CITY OF ALBUQUERQUE

Re: Manual Shops
7212 Manual Blvd 87110
60-Day Temporary Certificate of Occupancy
Transportation Development Final Inspection
Engineer's/Architect's Stamp dated 6-3-19 (H19D040)
Certification dated 7-27-20

Re: 7212 MENAUL Blvd NE
Alley

MENAU SHOPS
SITE PLAN
7212 MENAU BLVD NE 87110
ALBUQUERQUE, NM
PROJECT #1822

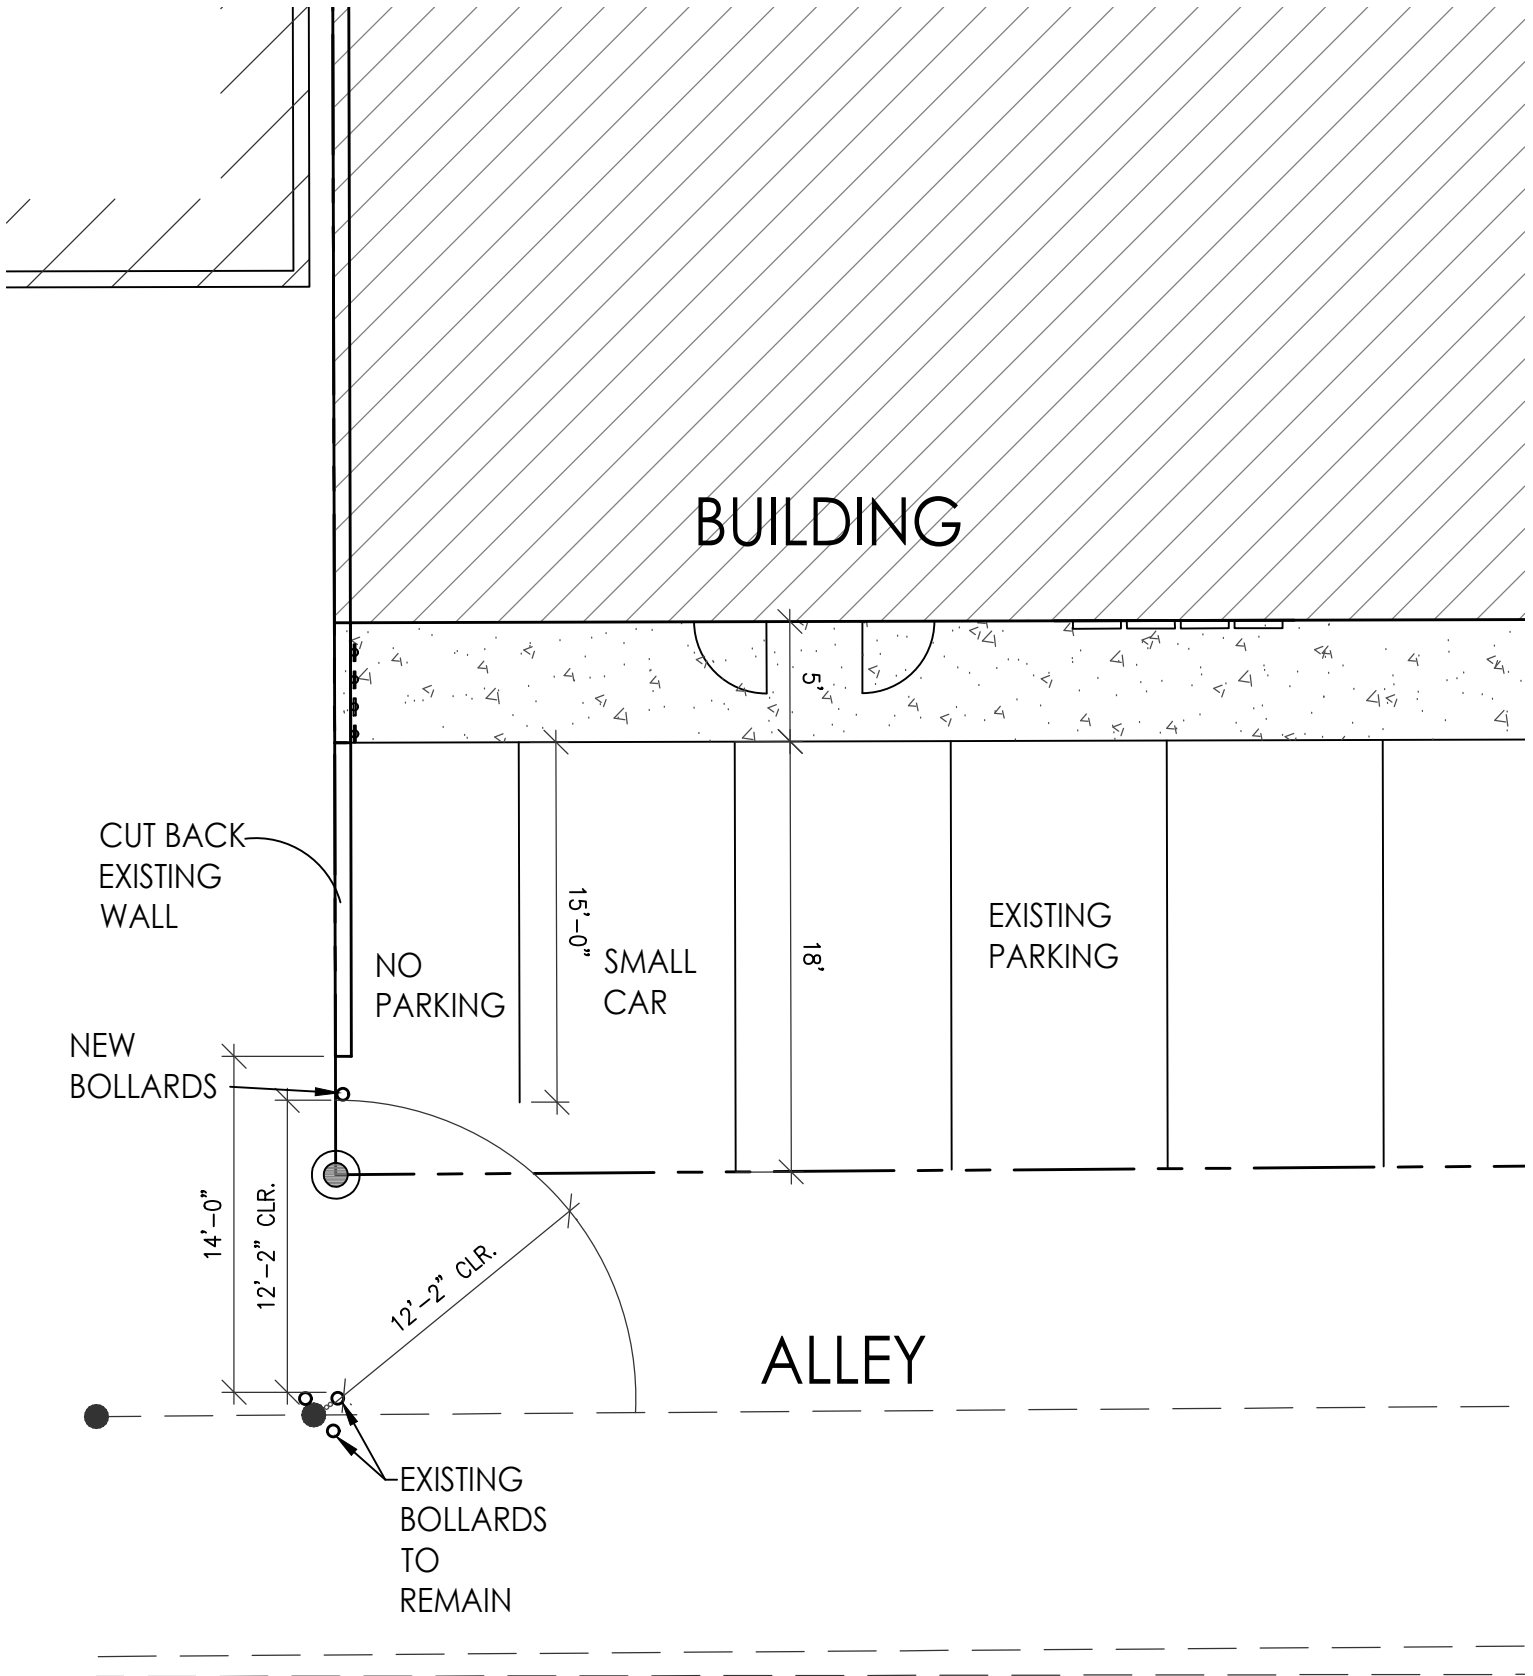
- Please cut back the wall as shown on the plan and label No Parking and label Compact stall.

We will cut the wall back and eliminate one parking space and convert one regular space into a small car space. The clear opening will not be less than 12'-0" from the existing bollards to the new bollard installed to protect the wall. There will be 12'-0" clear at all points north of the power pole (see attached drawing).
